**ZRD2: Zoning Challenge  
with response**

The current approved and permitted application is for a 25 story residential, mixed use new building with Community Facility on an interior zoning lot located entirely within C4-7 and the Special Lincoln Square District. The referenced posted ZD1 form (scan dated 7/26/2018), is associated with proposed post approval amendment (PAA) Document 16. It shall be noted that PAA Document 16 remains in disapproved status as there are unresolved Department issued objections. This scope is not yet accepted as part of the currently permitted application.

The amended scope in PAA document 16 proposes a 775 foot tall, 41 story building containing residential and community facility uses located on an enlarged zoning lot containing an existing 2-story landmark building (air-rights parcel). The proposed new zoning lot is split between an R-8 district and C4-7 district within the Special Lincoln Square District. The lot area is 19,582sf in the R-8 portion and 35,105 sf in the C4-7 portion. The challenger's reference the proposed scope in PAA Document 16 and the challenge points and Department response are below.

RE: Zoning Challenge  
36 West 66<sup>th</

**Summary of the July 26, 2018 ZD1**

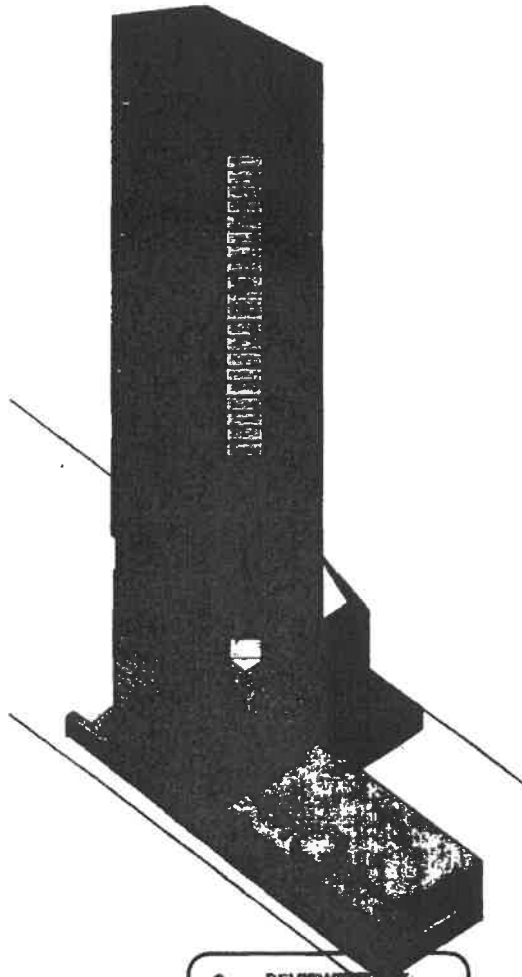
2. The Challenger states that the project in the posted ZD1 includes "oversized inter-building voids" used for accessory mechanical space.

The ZD1 section drawing shows a 42<sup>nd</sup> floor, which appears to be a roof level. There is neither a 42<sup>nd</sup> floor, nor a roof level shown in the Proposed Floor Area table. Further, the Proposed Floor Area table reads that the project proposed is 9.24 FAR. This is an error, as it omits all existing floor area to remain on the zoning lot while counting the lot area of the entire zoning lot. The actual proposed FAR is 10.03 (548,541 ZFA proposed / 54,687 SF of lot area). The difference is not trivial and amounts to over 43,000 ZFA that is missing from the table.

Response to Item 1: No ZR Section is cited in this portion of the Challenge. However, the applicant will be advised to make any necessary corrections to the zoning diagram (ZD1).

Response to Item 2: No ZR Section is cited in this portion of the Challenge. However, it is assumed the challenger is referring to floor 18, as indicated in the ZD1. Floor 18 is proposed mechanical space with a vertical distance of approximately 160 feet to the top of floor 19. The Zoning Resolution does not prescribe a height limit for building floors.

*Possible tower on base massing if the area for tower coverage is divorced from the area for bulk packing*

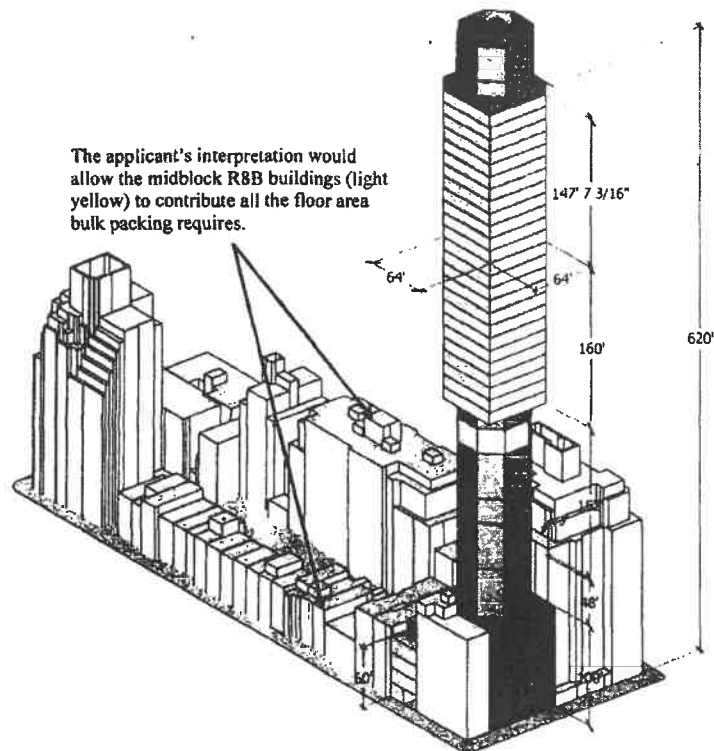
This is another R10 equivalent tower-on-base building with a massive void. Here, the R10 equivalent portion of the lot extends only 100 feet from the wide street the tower faces. If all floor area on the zoning lot under 150 feet can be counted for bulk packing outside the R10 equivalent portion of the lot, and the tower is only counted on the R10 equivalent portion of the zoning lot, then the zoning lot can be expanded to cover much of the block. If that is done, then *all* floor area under 150 feet, with the exception of the ground floor of the new building will be in buildings to stay on the lot. This zoning lot would require no transfer of development rights and would not impair the future development potential of the existing developments in the height limited mid-blocks. The following shows how such a building might be massed out:

The existing buildings added to the zoning lot are shown in light yellow in the midblock. They contribute substantially all the floor area under 150 feet that this new building needs so that the floor area generated on its own lot can be placed at levels higher than 150 feet. In the prior example there were 13 residential floors over 150 feet. With this interpretation and large zoning lot, 26 residential floors in the main portion of the building are over 150 feet. This example shows expanded mechanical floors acting as a platform to raise the building to 150 feet so that the height can be maintained. It could have just as easily been a single floor designed to be 150 feet floor-to-floor, which while sounding absurdly unrealistic, is actually 11 feet shorter than what the applicant is actually proposing on the 18<sup>th</sup> floor of their building.

*Detail of plan showing the small inner court*

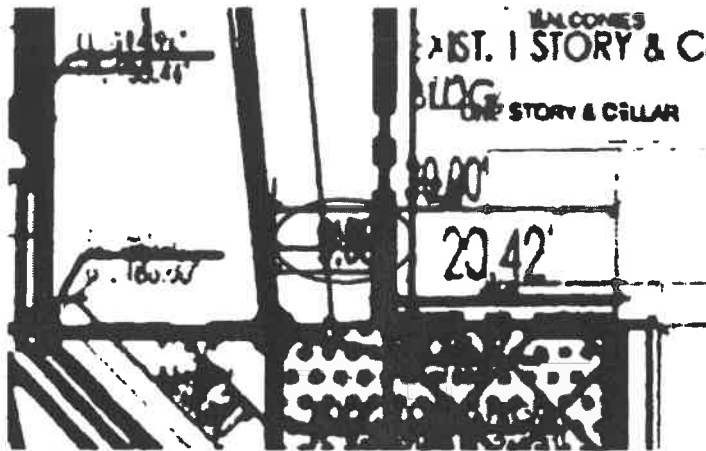
**5. The small inner court is too small.**

The ground level open space shown below is not a side yard because it does not extend to the front yard line. It is surrounded by building walls and a lot line, so therefore, it must be an inner court. While the numbers are hard to read on the ZD1, it appears that the plan shows the narrowest dimension for this small inner court to be just over nine feet.

The number shown appears to be 9.58 feet but that dimension is not taken at the narrowest location. ZR 23-851(b)(2) requires that this inner court be at least 10 feet wide. The zoning approval should be revoked.
